ABINGTON TOWNSHIP

BOARD OF COMMISSIONERS WORKING SESSION

- a. Receive public comment on the Township's cable franchise renewal with Comcast.
- b. Review and discuss the request by Toll Mid-Atlantic, L.P. Company, Inc. (Toll Brothers) for a Zoning Text Amendment to create the AR - Age-Restricted Carriage Home Overlay District and a Zoning Map Amendment to rezone certain parcels on the northeast side of Fox Chase Road as AR - Age-Restricted Carriage Home overlay.

SUBJECT: Sketch Plan and Zoning Ordinance: Age-Restricted Carriage Homes on Fox Chase Road

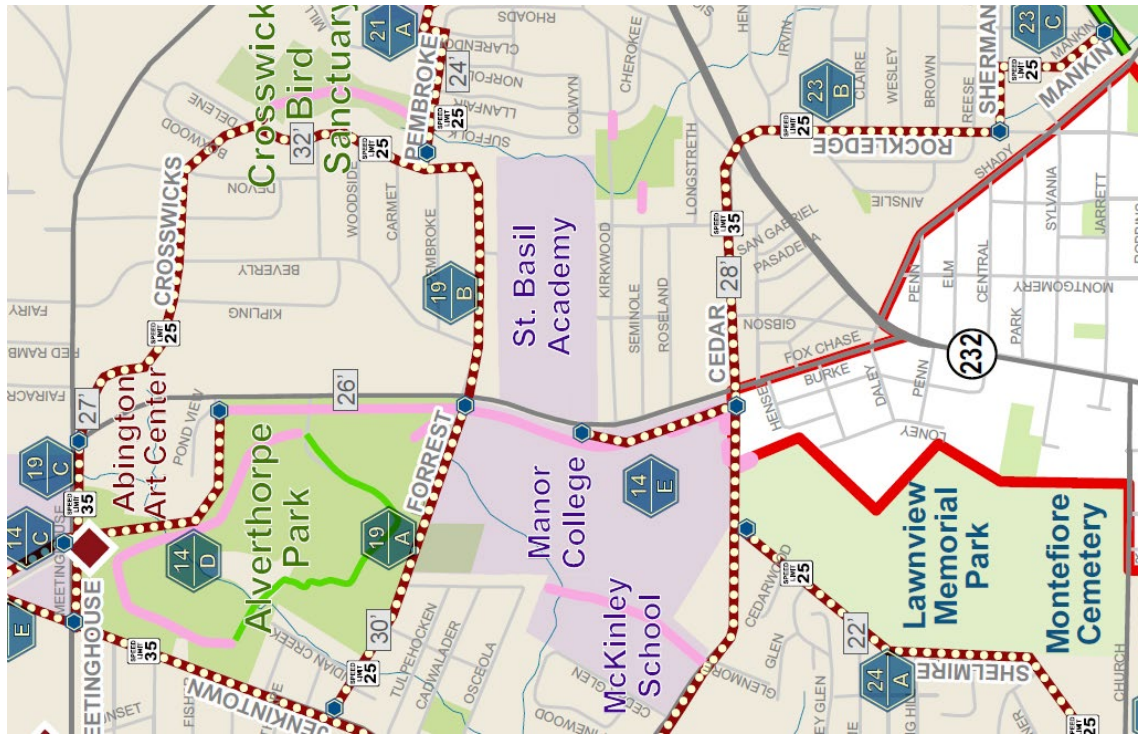
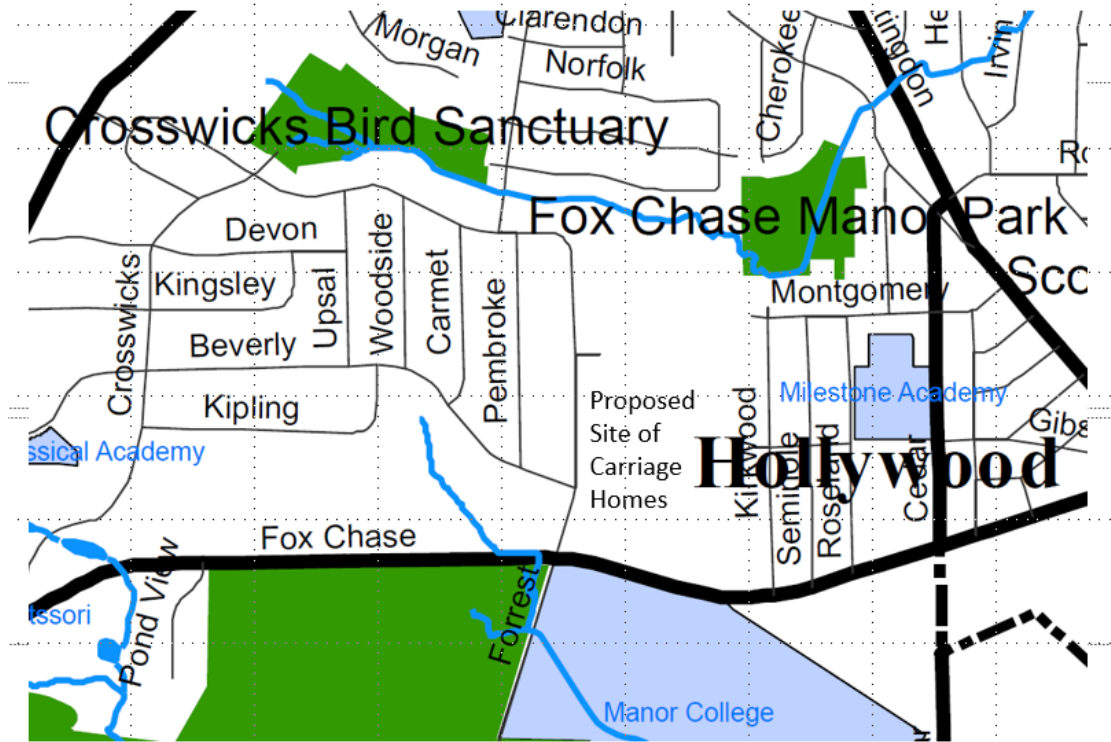
3. Open Space.

- a. There is not enough usable open space.
- b. Open space is subject to the requirements of §2601.K.
 - i. Open space shall be visible from dwellings and roadways.
 - ii. Open space area must have safe and convenient pedestrian and maintenance access, without obstruction of an intervening lot(s), structures, fences, or other impediments.
 - iii. No more than three noncontiguous areas may count towards the open space requirements.
- c. Guest parking should not be allowed in the open space.

- d. Could a trail be located in the stream corridor? Eventually it might connect to Fox Chase Manor Park. Short, through-block trails might also be considered.

- e. Proposed amendment, section 1712.C.: Land preserved for open space purposes shall be in compliance with Open Space Standards of the SALDO for the and Township Zoning Ordinance; provided however that ...
- f. The tract buffer seems unnecessarily large. We recommend locating a trail in the buffer.

CONCEPT "L"
150 ACTIVE ADULT CARRIAGE HOMES
SISTERS OF ST. BASIL
ABINGTON TOWNSHIP, MONTGOMERY COUNTY, PA

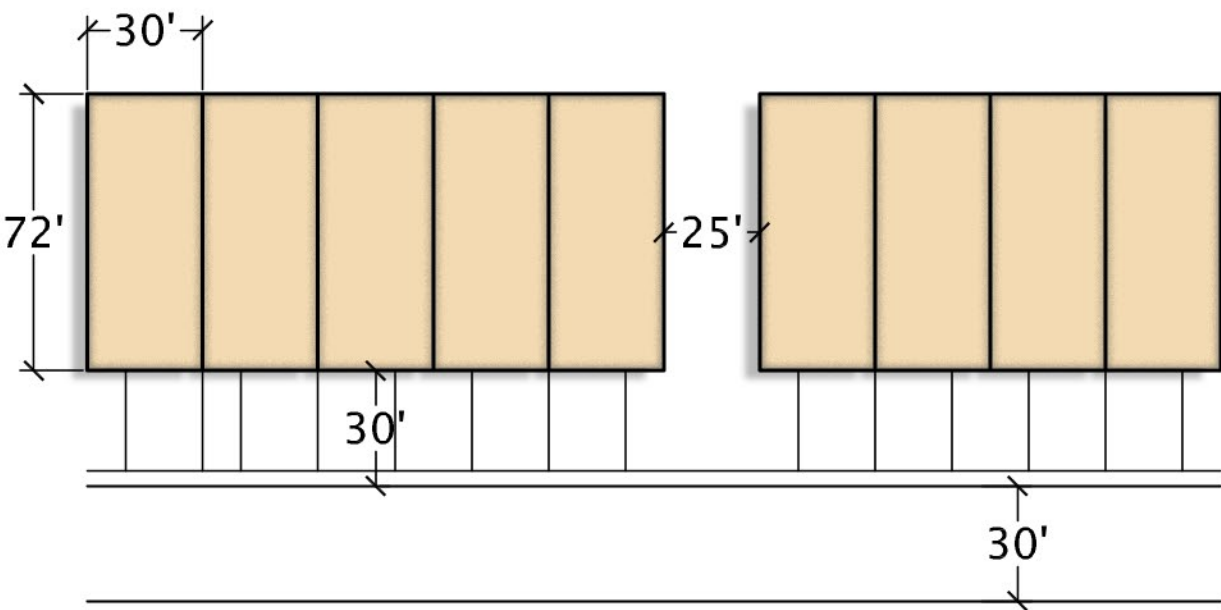
- A. General Comment. In order to accommodate a wide grass area surrounding the tract in the interest of privacy and security of existing residents, the resulting proposed neighborhood seems unfortunately packed together and isolated from the surrounding community, with little visual relief and open space which does not serve to provide usable, active open space for the development's residents nor for the adjacent neighborhoods. Most of the open space would consist of a grass buffer with no access, and thus provide neither ecological nor recreational benefits.

1. Open space is subject to the requirements of the existing zoning ordinance's §2601.K. Very little of the open space shown on the proposed sketch plan would seem to meet the requirements, including:

2. Usable, Central Open Space. Proposed open space is difficult to discern on the sketch plan. It appears to consist of the pool, clubhouse, and a few small areas which might take the form of pocket parks if they were designed as such. We recommend that sidewalks, trails, and any other facilities that would increase the usability of the open space be shown (e.g., picnic area, gazebo, and community garden).

3. Riparian Corridor. The site is subject to the requirements of Article XV: the Riparian Corridor Conservation District. We recommend the boundaries of the corridor be designated on the plan.

The applicant agreed to take another look at the intersection design shown on the sketch plan.

SUBJECT: Sketch Plan and Zoning Ordinance: Age-Restricted Carriage Homes on Fox Chase Road

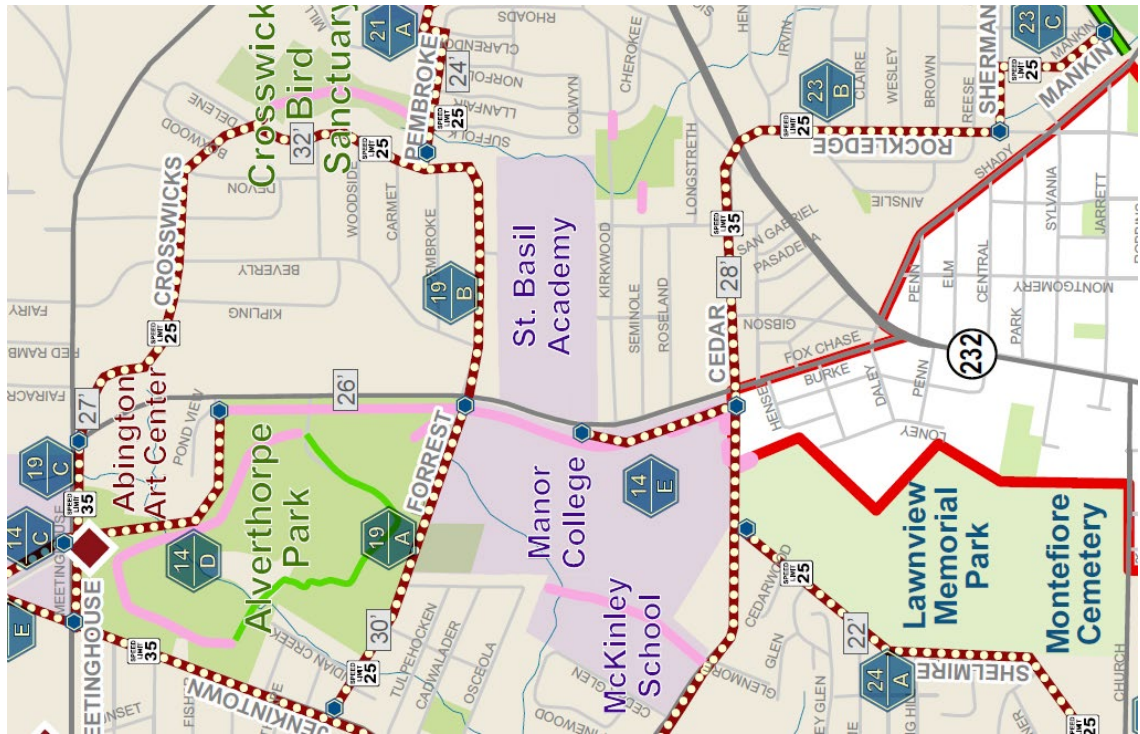
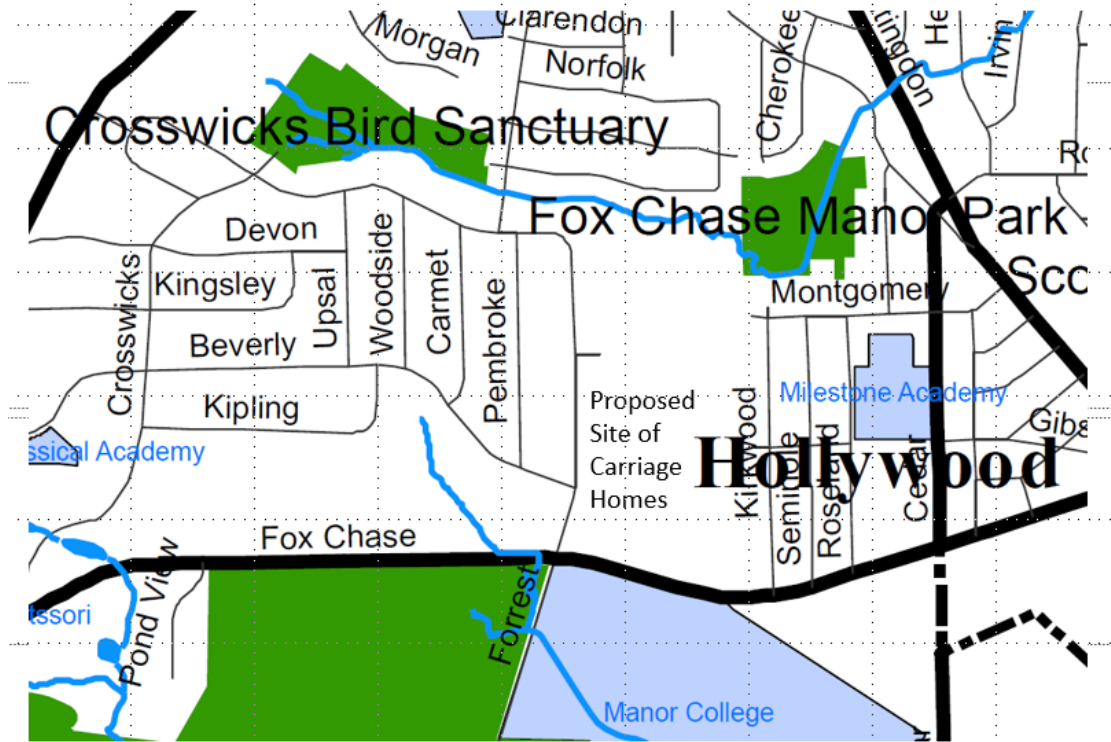
3. Open Space.

- a. There is not enough usable open space.
- b. Open space is subject to the requirements of §2601.K.
 - i. Open space shall be visible from dwellings and roadways.
 - ii. Open space area must have safe and convenient pedestrian and maintenance access, without obstruction of an intervening lot(s), structures, fences, or other impediments.
 - iii. No more than three noncontiguous areas may count towards the open space requirements.
- c. Guest parking should not be allowed in the open space.

- d. Could a trail be located in the stream corridor? Eventually it might connect to Fox Chase Manor Park. Short, through-block trails might also be considered.

- e. Proposed amendment, section 1712.C.: Land preserved for open space purposes shall be in compliance with Open Space Standards of the SALDO for the and Township Zoning Ordinance; provided however that ...
